ALVEY SUBDIVISION
Final Subdivision Plat
FSP 2020-090021

Planning Commission Recommendation – Final Plat

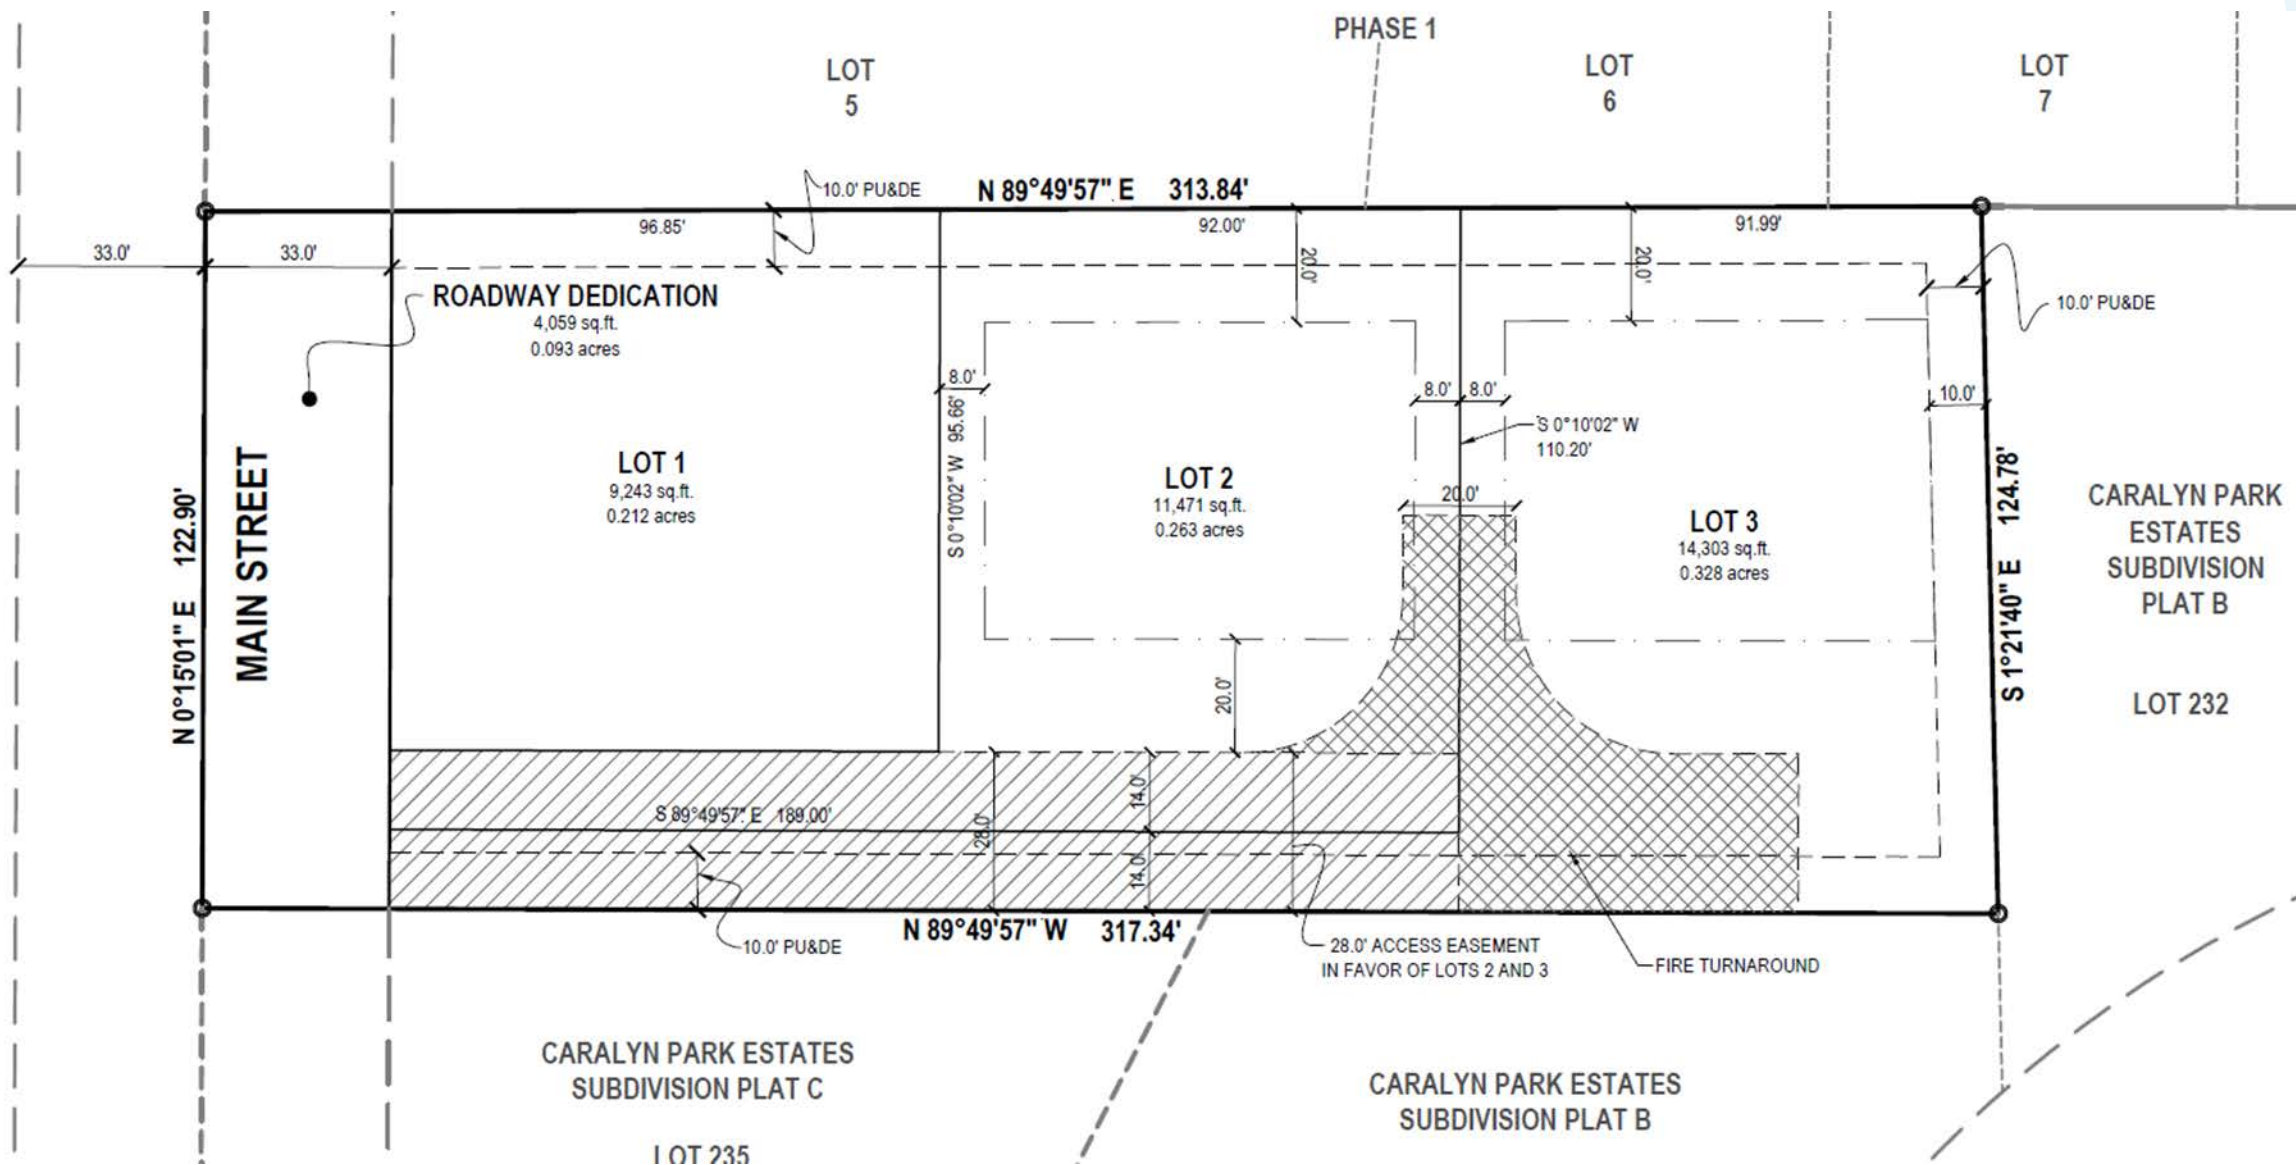
- 1) The setbacks and buildable area for lot 3 shall be revised to have the west property line (shared property line with lot 2) as the front lot line and front yard. The north and south property lines are to be the side yards, and the rear yard the east property line.
